# **P802.3ae Logic Track Summary**

P802.3ae TF Logic Track Chair

12-January-2001

# Overlay of All S21 Data

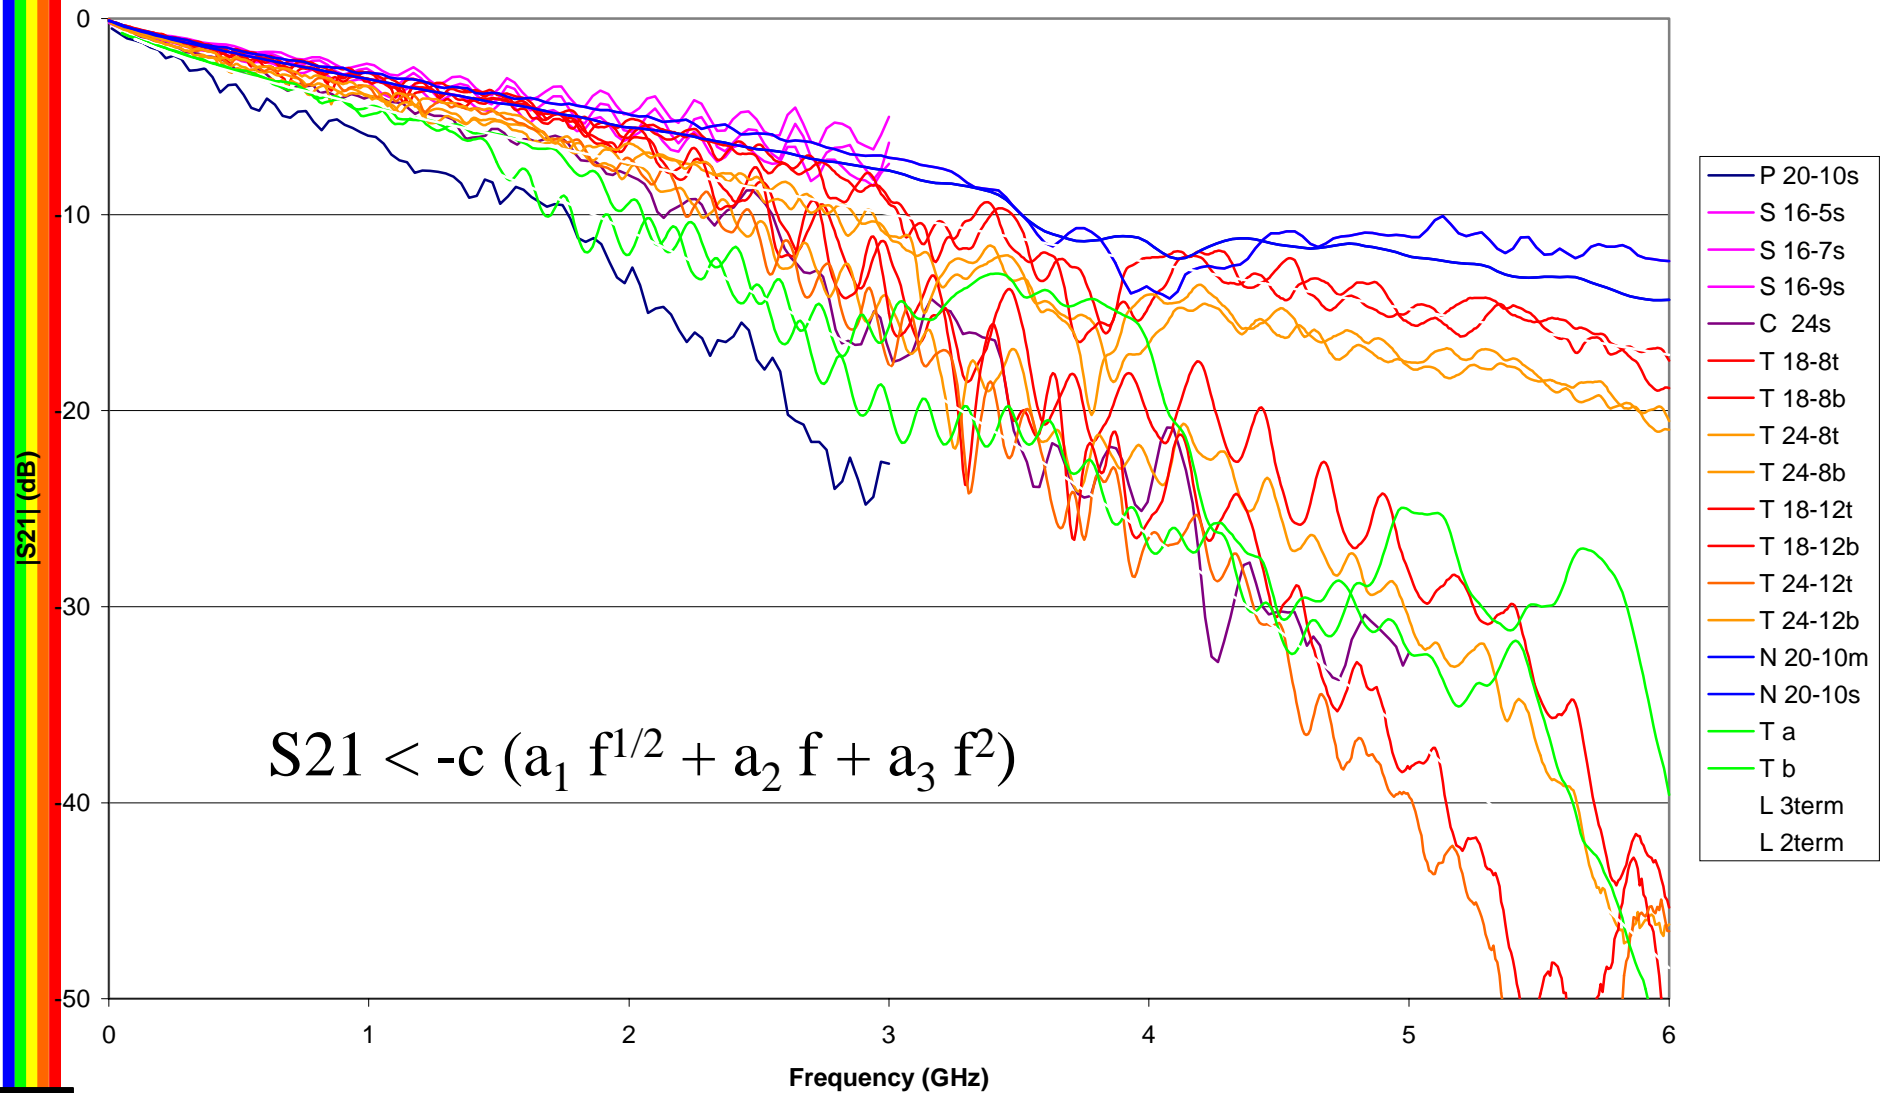
- Compliance Channel Breakout
  - Agreed on loss characteristics for D2.1
  - Agreed on ISI limit for D2.1
- Jitter Breakout
  - Solidified the jitter methodology for D2.1
  - Agreed on jitter spec's
  - Assigned actions to complete test patterns by March
- Comment Resolution
  - Resolved all major comments from D2.0
  - Approved editor's responses for all minor comments
  - Approved values to replace remaining TBD's in D2.1
  - Approved addition of a Jitter Measurement subclause

- Finalize jitter test patterns
- Confirm channel group delay spec with more data
- Complete interface simulations
  - To make sure that various interdependent spec's are consistent: jitter, connectors, return loss, compliance channel, eyes, etc.
